Sakhalin-2 Phase 2
Lenders' Independent Environmental Consultant
Monitoring Report
October 2014

Prepared for:
**Sakhalin-2 Phase 2
Project Finance Parties**

Prepared by:
ENVIRON UK

Date:
February 2015

Photo 3.3 Lack of daily cover at Nogliki Landfill

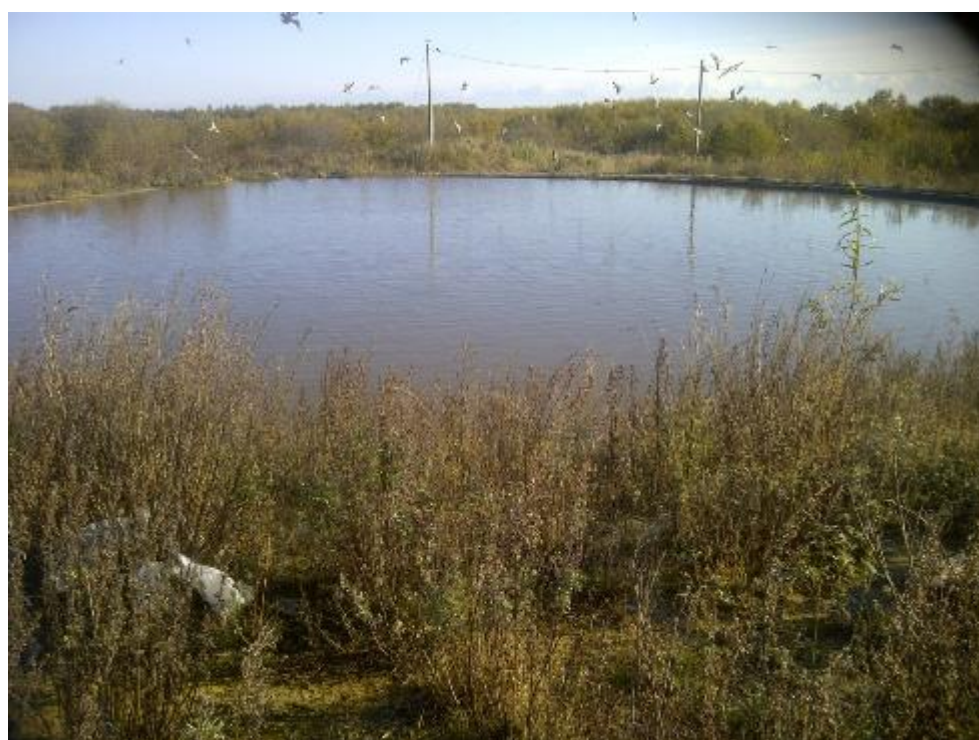
- A site visit to the Korsakov landfill found that this facility continues to be managed to a high standard, although the issues with limited remaining capacity are also evident.
